Lancaster County School District Amendment #1	Solicitation Number	202502	
		Solicitation Issue Date	07/30/24	
		Amendment Issue Date	8/12/24	
		Procurement Officer	Trevor Hammond, NIGP-CPP, CPPB (803) 416-8828	
		E-Mail Address	trevor.hammond@lcsd.k12.sc.us

DESCRIPTION: **Restrooms for BHS & LHS Baseball Fields**

Effective this date, this amendment forms part of the contract documents and modifies the original IFB

SHEET NAME:
EXTERIOR ELEVATIONS

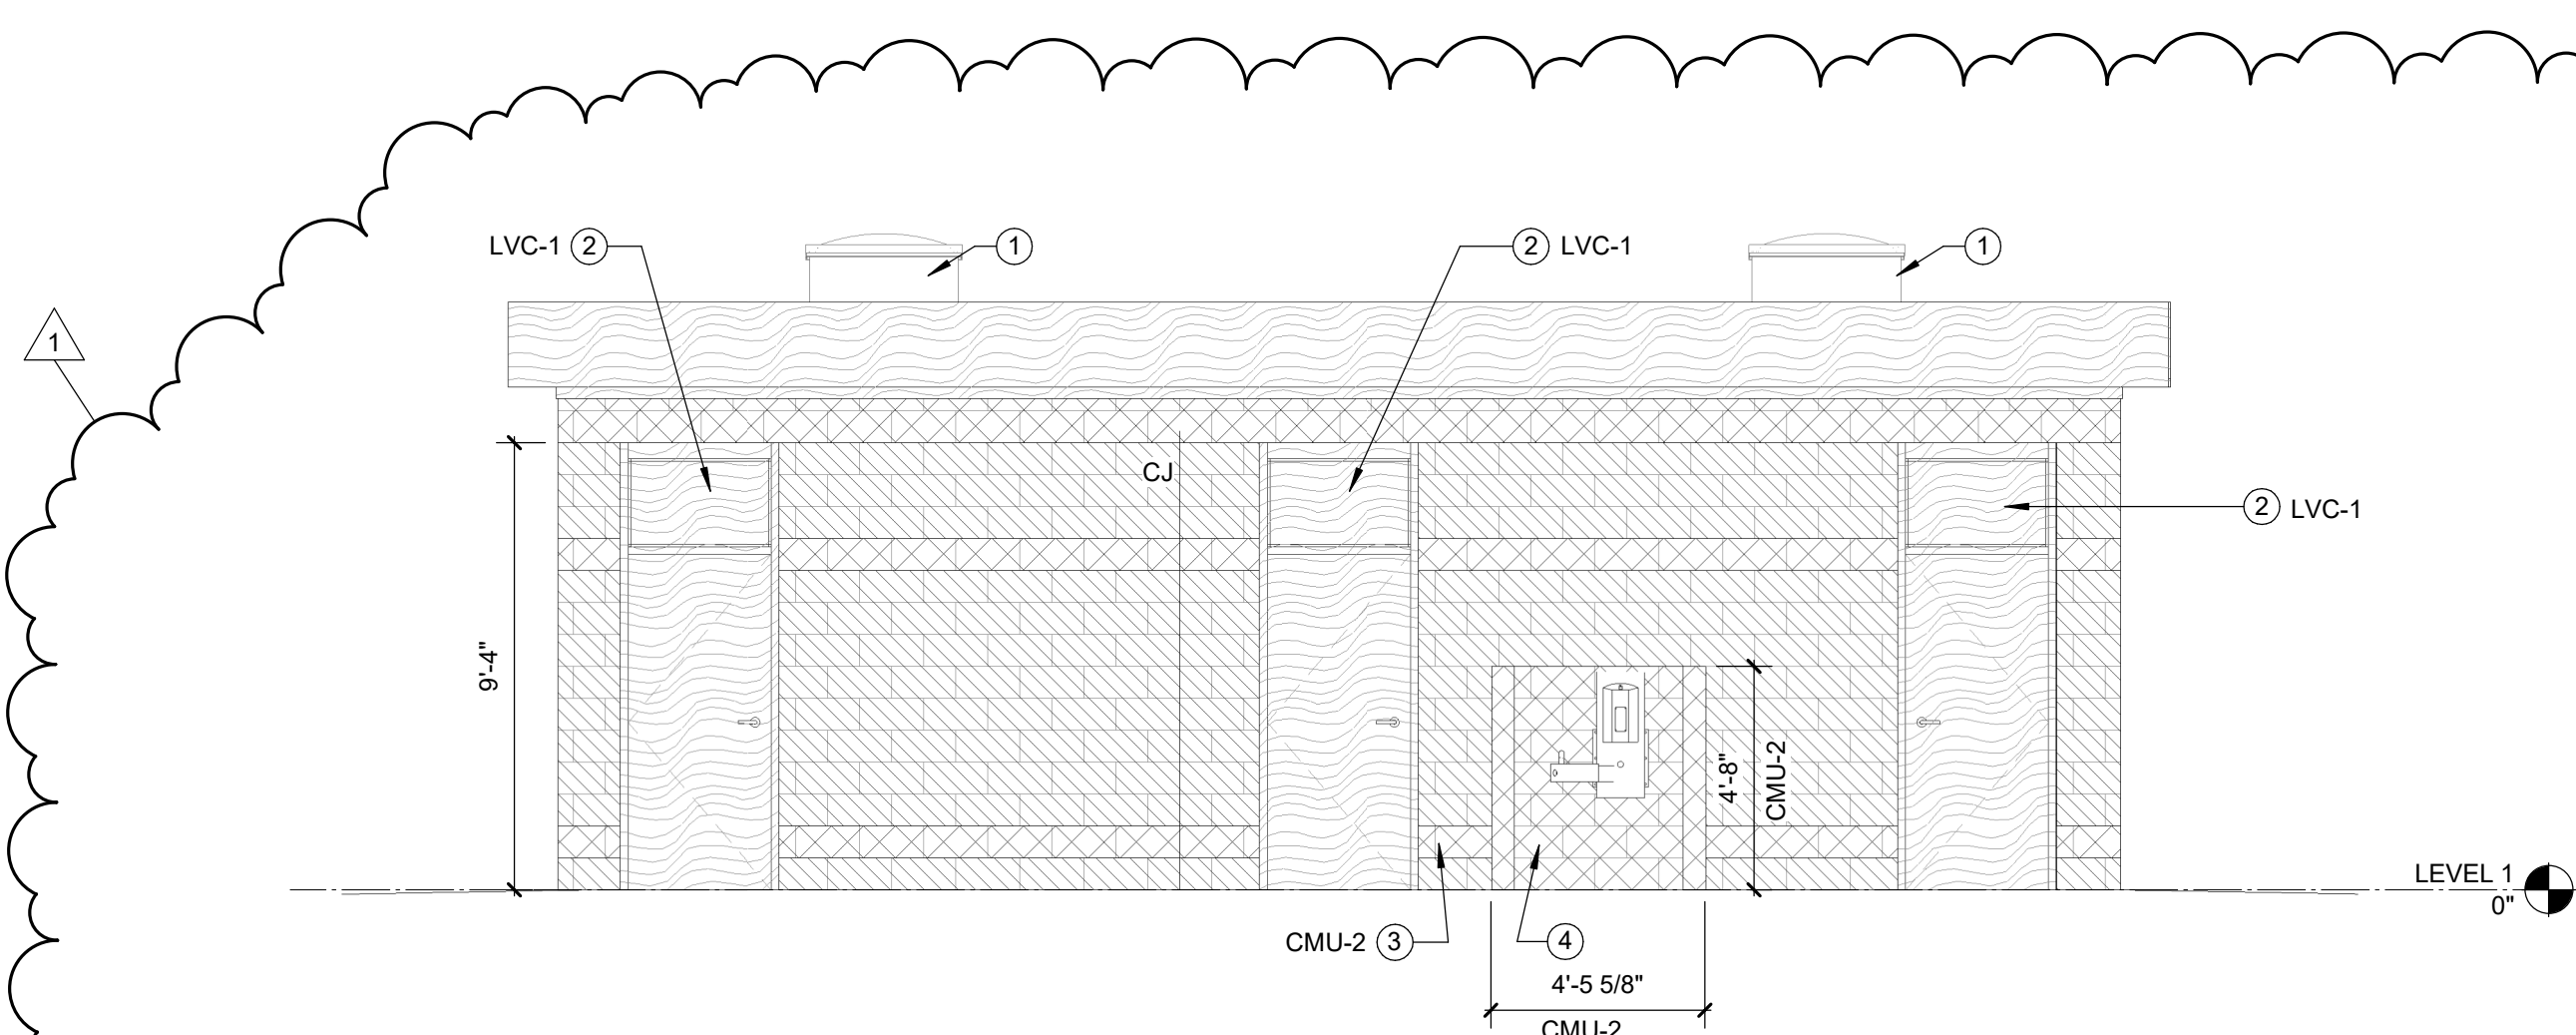
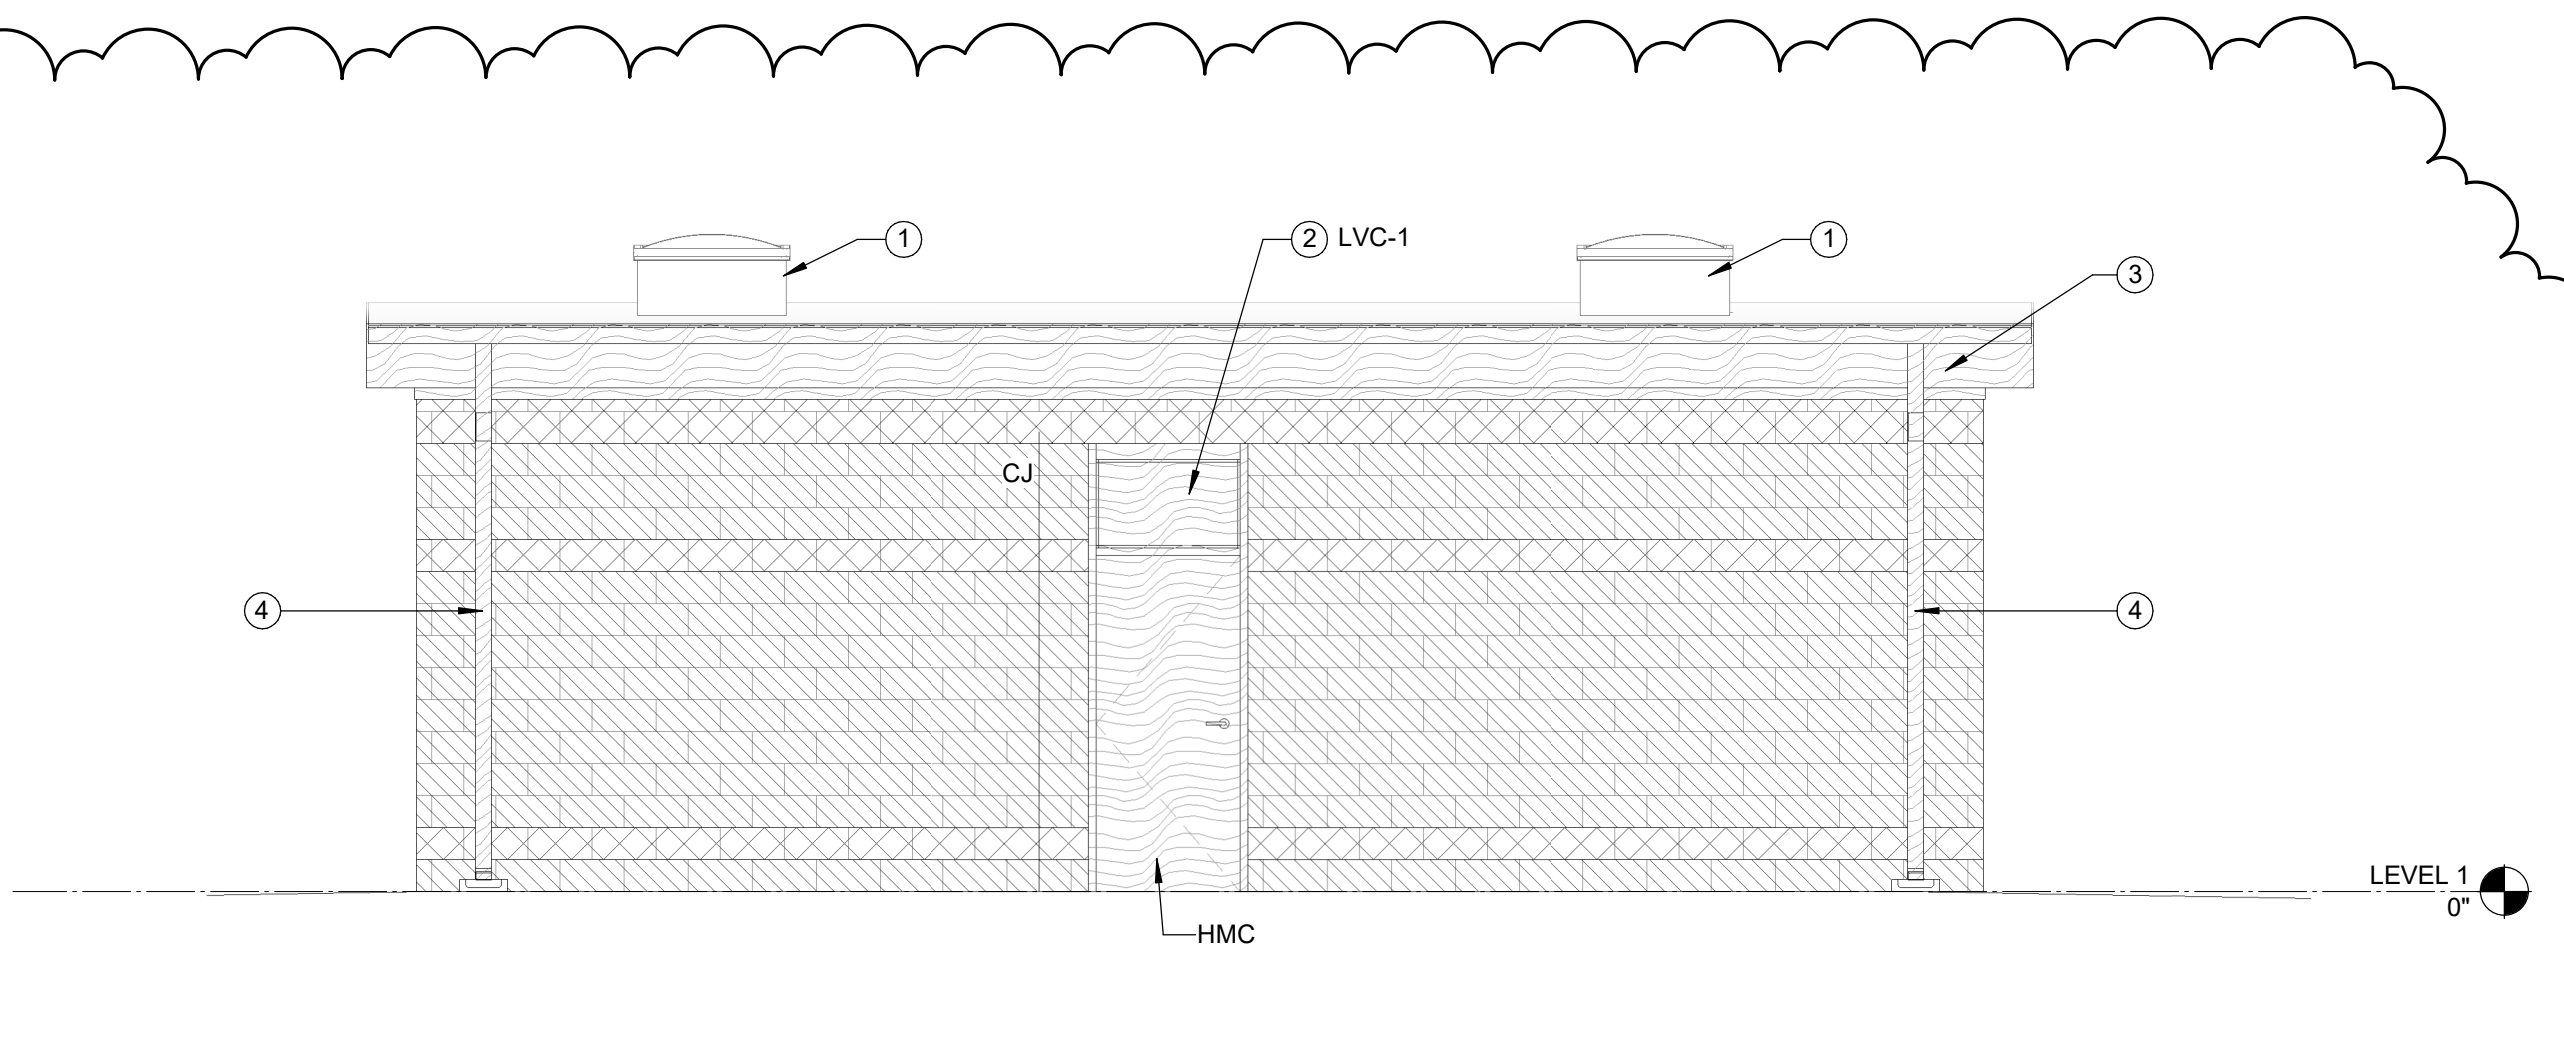
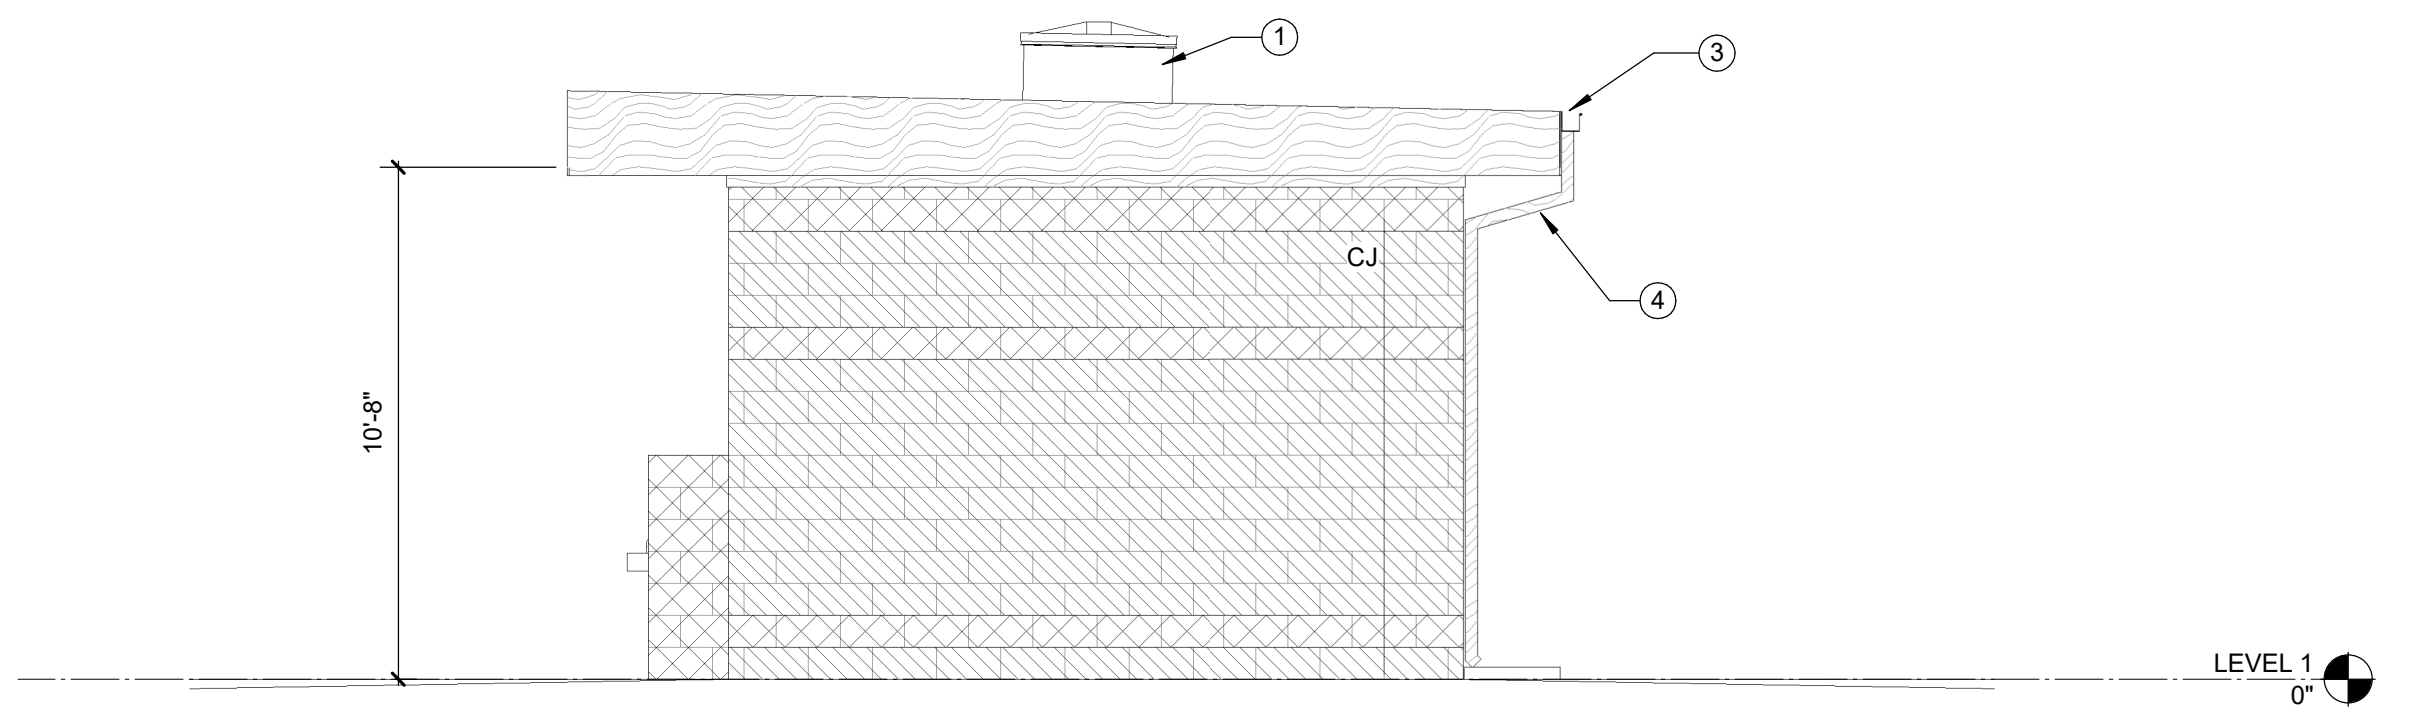
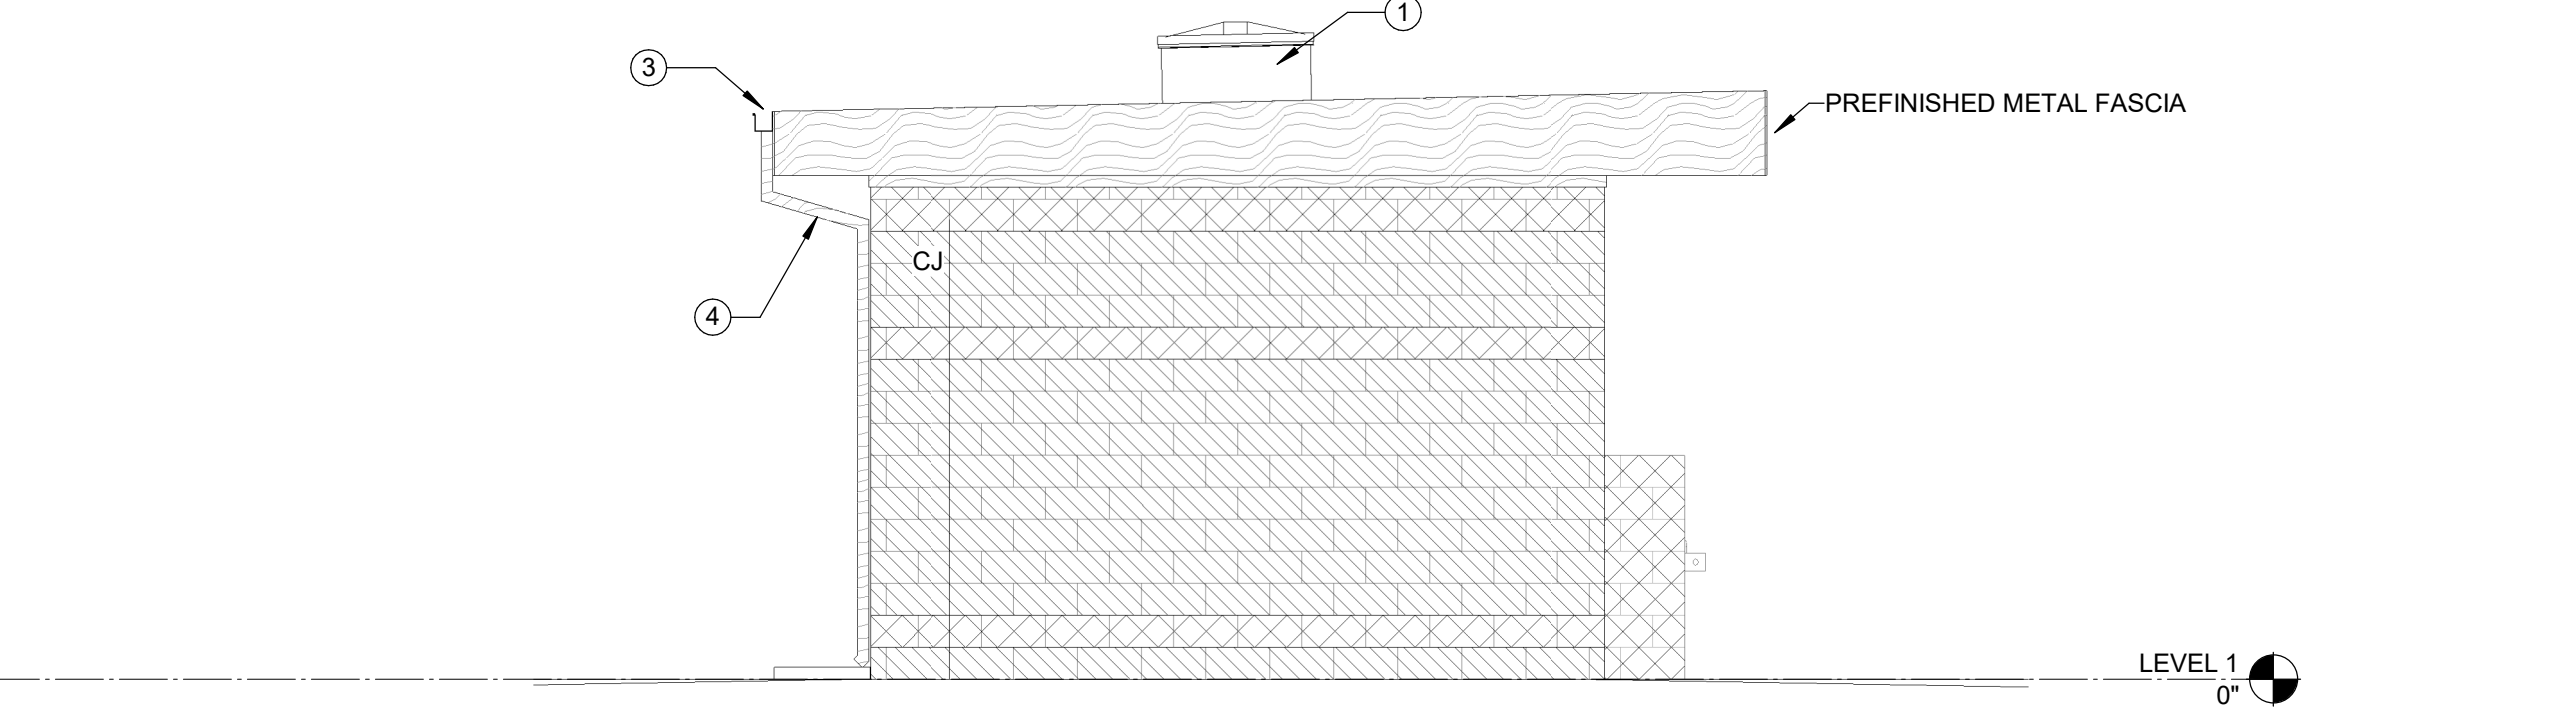
1. Painting the existing exterior stair handrail was added to the project scope.
- E. Replace Sheet A-201 with revised sheet A-201 – Exterior Elevations, included in the Attachments.

1. Elevations, legend and schedule were revised to remove exterior block that was to be painted in lieu of colored smooth and split face CMU.

SHEET:
G-003

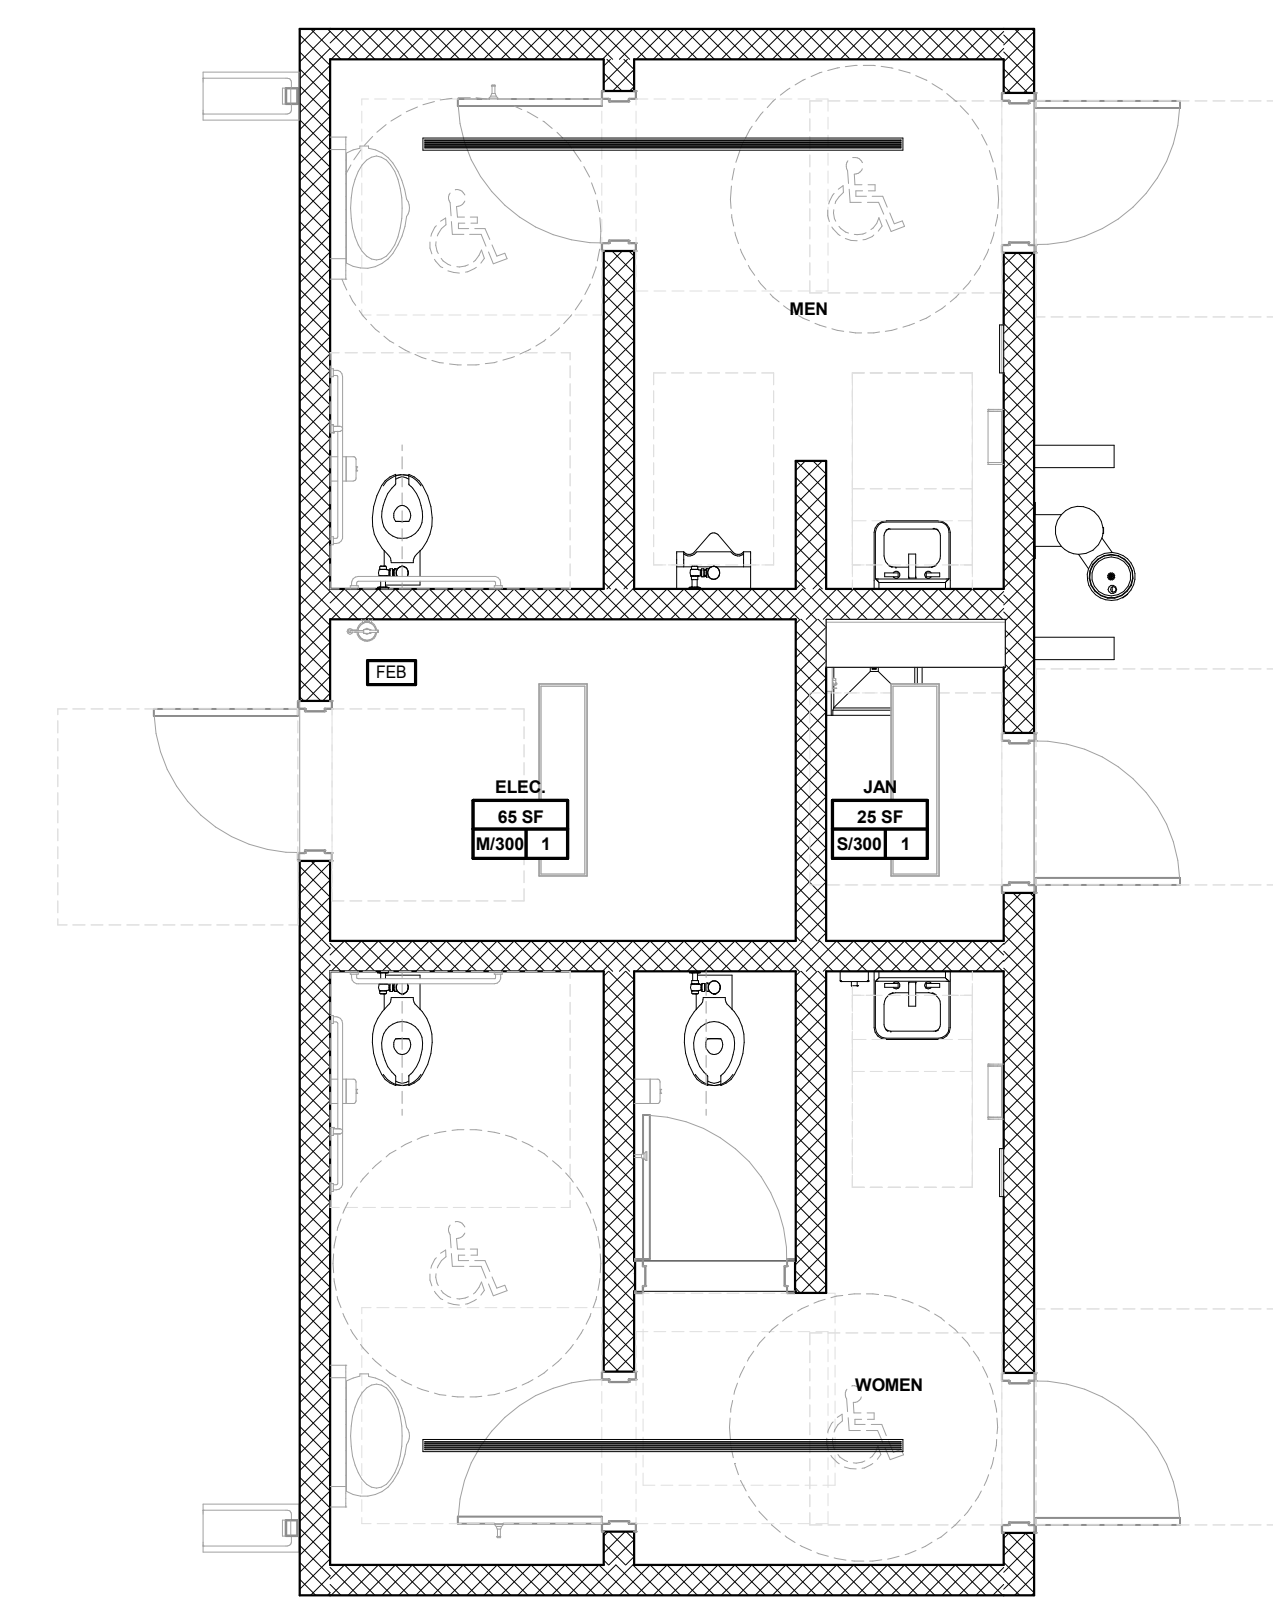
- A. Replace sheet G-003 with revised sheet G-003 – Life Safety Plan, included in the Attachments.
 1. A temporary fencing plan was added to this sheet to show material laydown space and the enclosed areas of work.
